Subject: 10CFR21 Reporting of Defects and Non-Compliance -
Engine Systems, Inc. Report No. 10CFR21-0128, Rev. 0

Selenium Surge Suppressor, EMD P/N 8403049

Report No. **10CFR21-0128**

10CFR21 REPORTING OF DEFECTS AND NON-COMPLIANCE

Figure 1: Outline Drawing of Selenium Surge Suppressor P/N 8403049

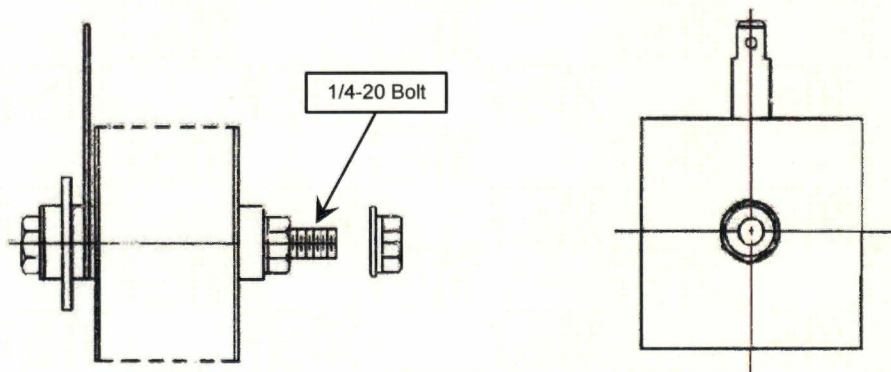
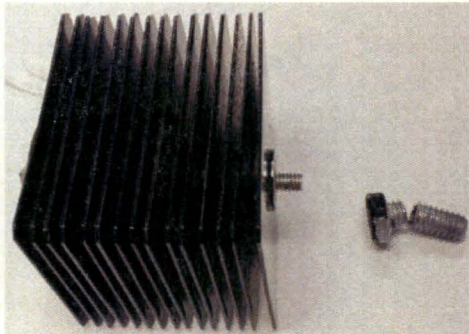
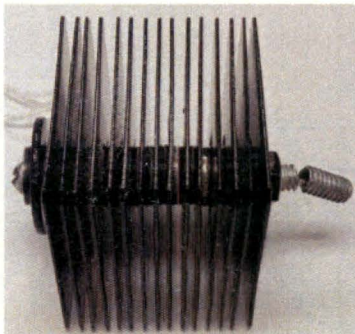
Three batches of selenium surge suppressors supplied by ESI between 2011 and 2013 utilize a thread modification that is inadequate for the application. The design specifies the use of a single 1/4-20 x 2-3/4" long bolt to compress the stack of selenium cells as well as mount the suppressor (see Figure 1). Contrary to this requirement, the manufacturer used a #8-32 screw through the body of the stack and added a modified bolt to obtain the required 1/4-20 mounting threads. The modified bolt consisted of a 1/4-20 x 5/8" long bolt that was drilled and tapped in the head to accept #8-32 threads. An attempt to install the selenium surge suppressor by tightening the corresponding mounting nut may result in failure of the modified bolt threads. See photos 1, 2, & 3.

- For surge suppressors installed, these are functionally acceptable but may be structurally compromised. The concern is the mounting nut may have unknowingly been tightened beyond the allowable strength of the bolt which could eventually cause the mounting system to fail. ESI recommends inspection and/or replacement at the next opportunity.*
- For surge suppressors not installed, ESI recommends they be returned for replacement.*

This part number has been discontinued and ESI will offer new selenium surge suppressor P/N 8403049-ESI made by a different manufacturer but to the original drawing and design requirements. Within the new dedication package, ESI will include an inspection to verify the issue described in this report is not present. The time frame to source new suppressors and complete dedication activities is 12 weeks.

Figure 2: Rectifier Assembly P/N 8334736 (containing P/N 8403049)

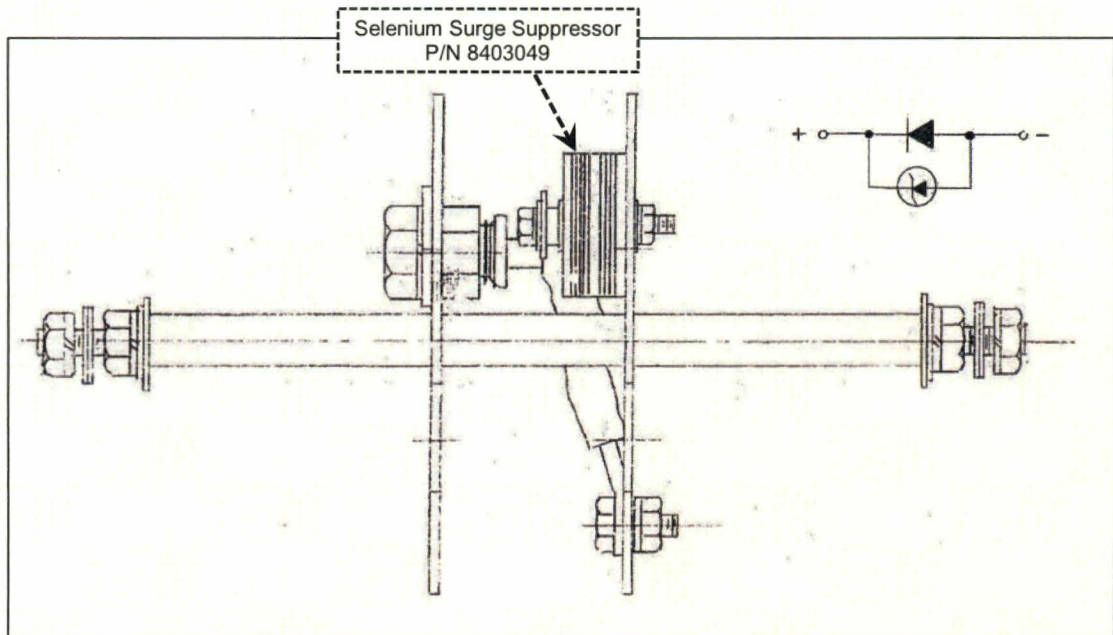
The selenium surge suppressor is a subcomponent of rectifier assembly P/N 8334736 (see Figure 2) used in the Vickers voltage regulator system. The rectifier assembly is shown as components CR1 through CR6 in Figure 3 and each function as a half wave rectifier, used in the static exciter, to furnish DC voltage for excitation of the generator field. The selenium surge suppressor protects the diode from surges by clamping at a voltage below the critical voltage for the diode, thus conducting around the diode at high energy levels.

Use of this thread modifier significantly reduces the strength of the mounting threads. Failure of the mounting threads creates the possibility of the suppressor dislodging with the potential to electrically short between the positive and negative plates of the rectifier assembly. An electrical short would affect output of the voltage regulator system which may prevent the emergency diesel generator set from performing its safety-related function. This issue is therefore considered to be a reportable defect as defined by 10CFR-part 21.
